Neighbourhood Report-Back

400 Block Clarence Ave
Revised Design Concept

Fall Equinox — Mid-Range Sun Angle

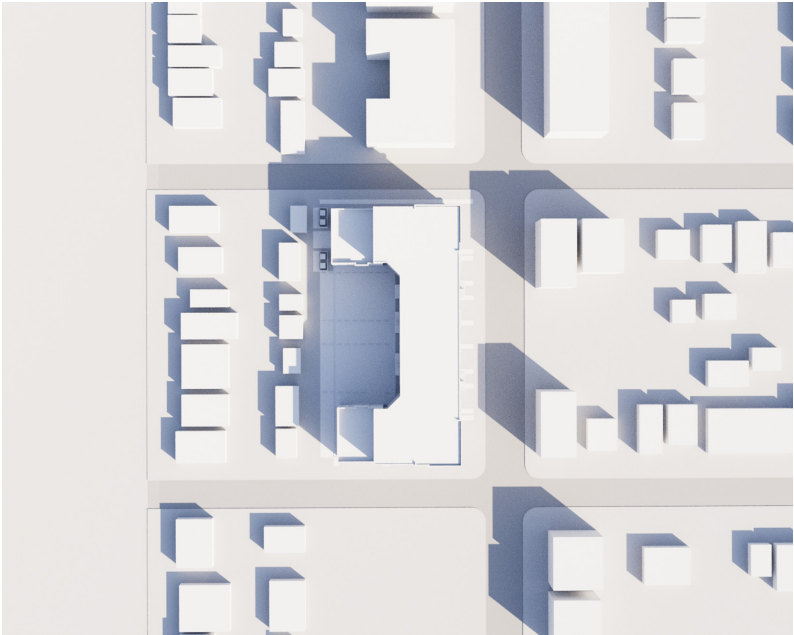
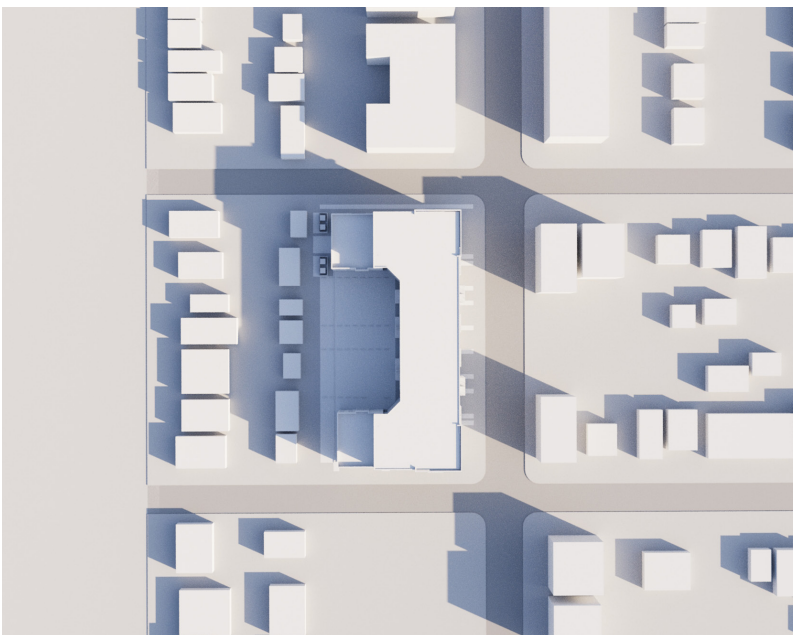
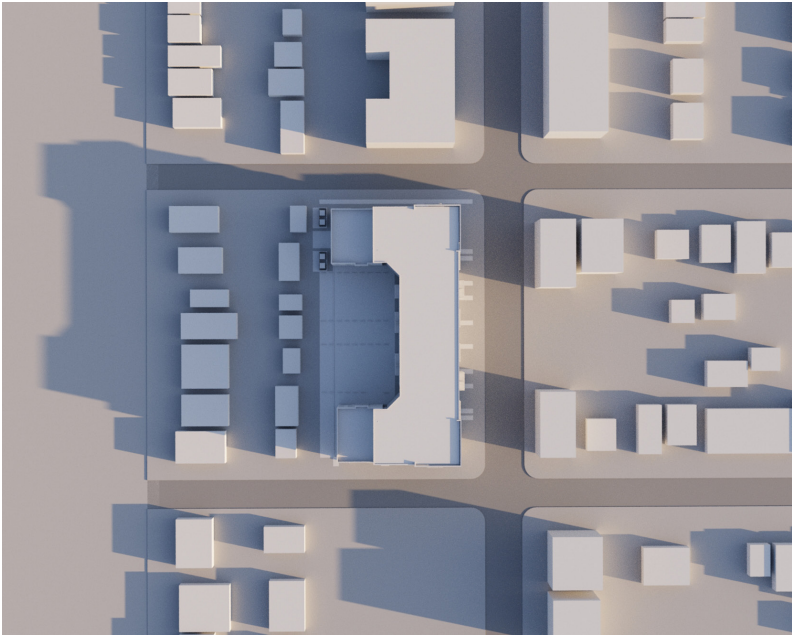
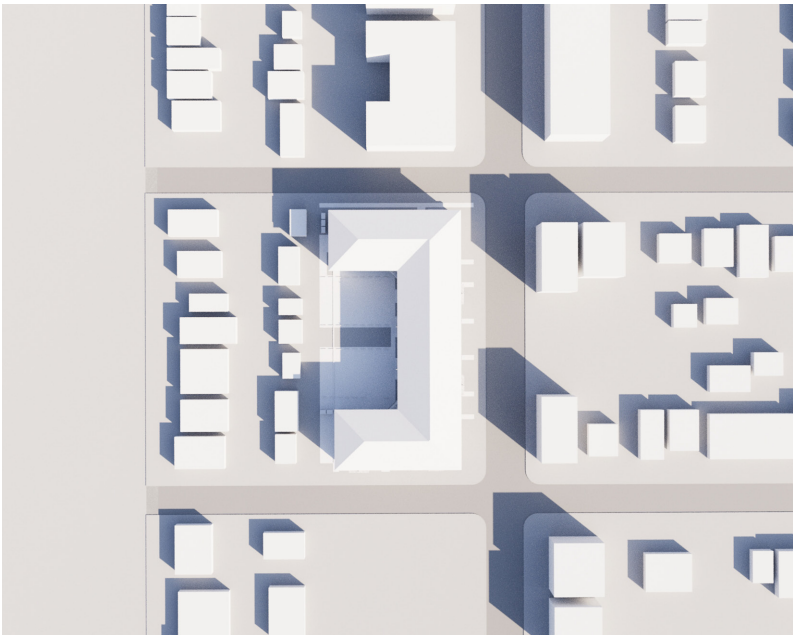
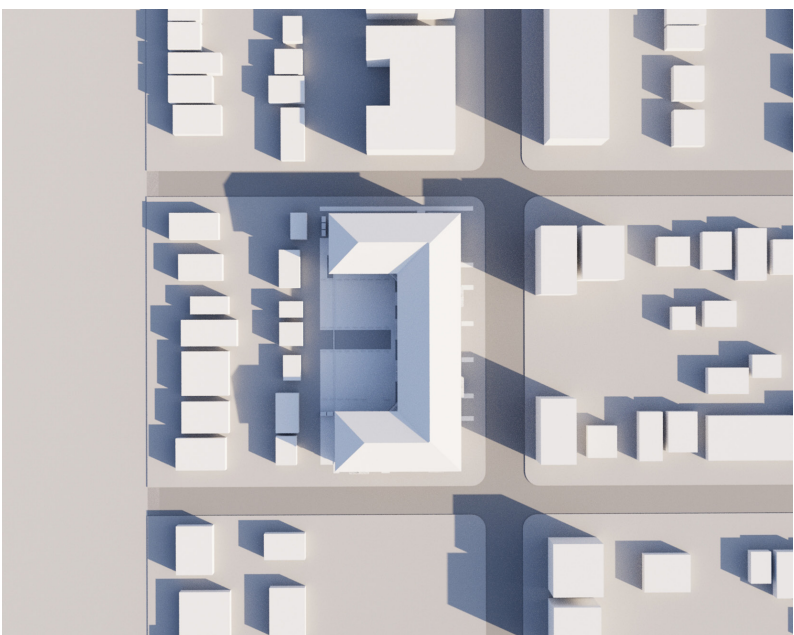
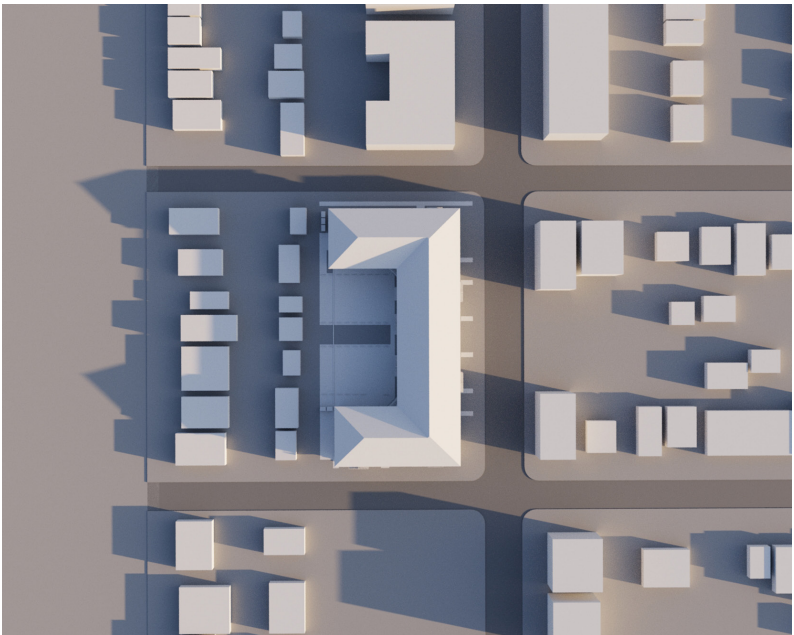
- Neighbours requested a clearer understanding of shadow impacts
- Yards facing the lane were of particular interest
- Concerns around rooftop solar PV performance

Finding: Shadow impact comparable to current zoning

1 SITE PLAN
1:200

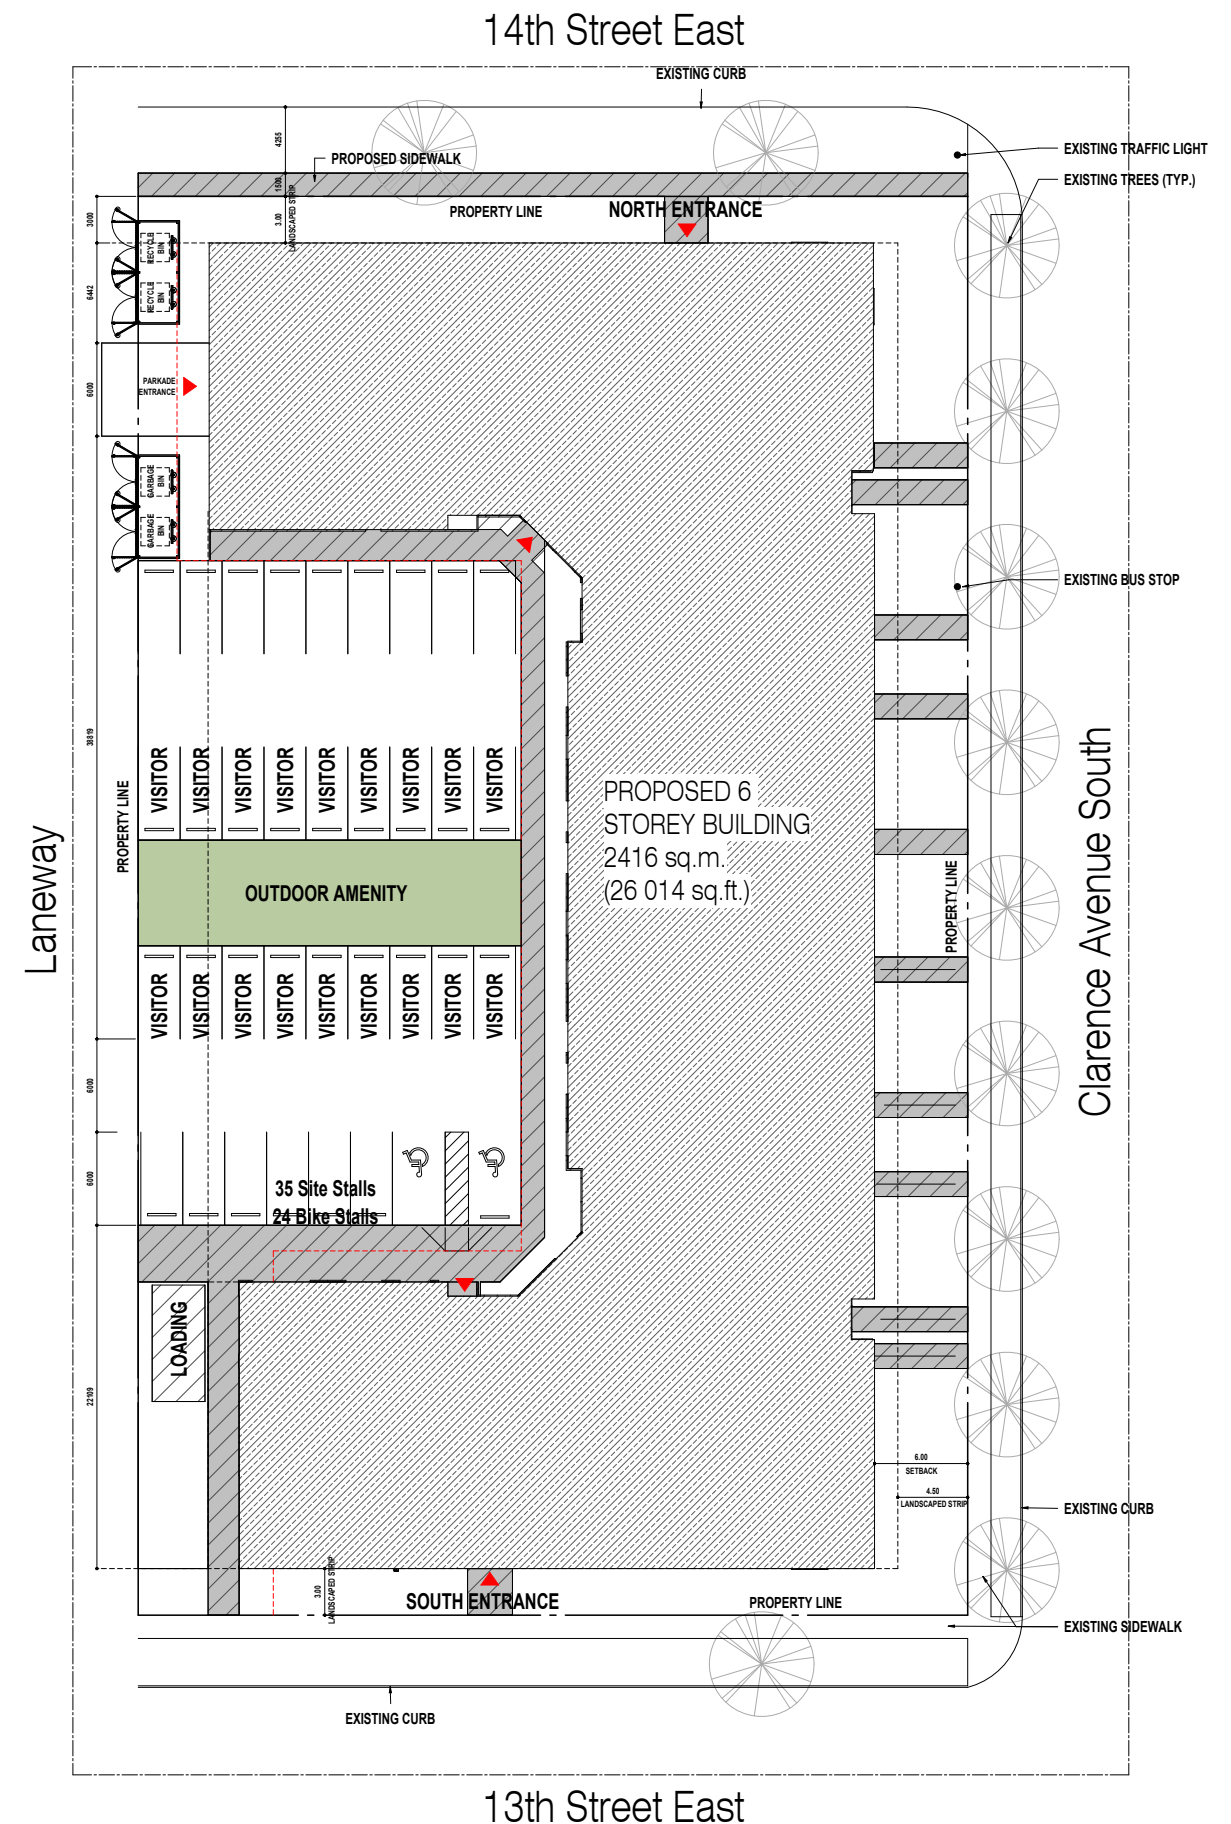
- Concerns around tree protection during construction
- Questions regarding hazardous material removal during demolition
- Construction impact on neighbouring properties was discussed

- Commitment to meet all City of Saskatoon permitting and bylaw requirements
- Demolition and Environmental Safety measures
- Safe Asbestos removal
- City boulevard tree protection during construction

- A protection plan will be included as part of the permitting process.
- Boulevard trees will be marked with proposed protection measures.
- Development distance requirements will be met as per City of Saskatoon Bylaw.
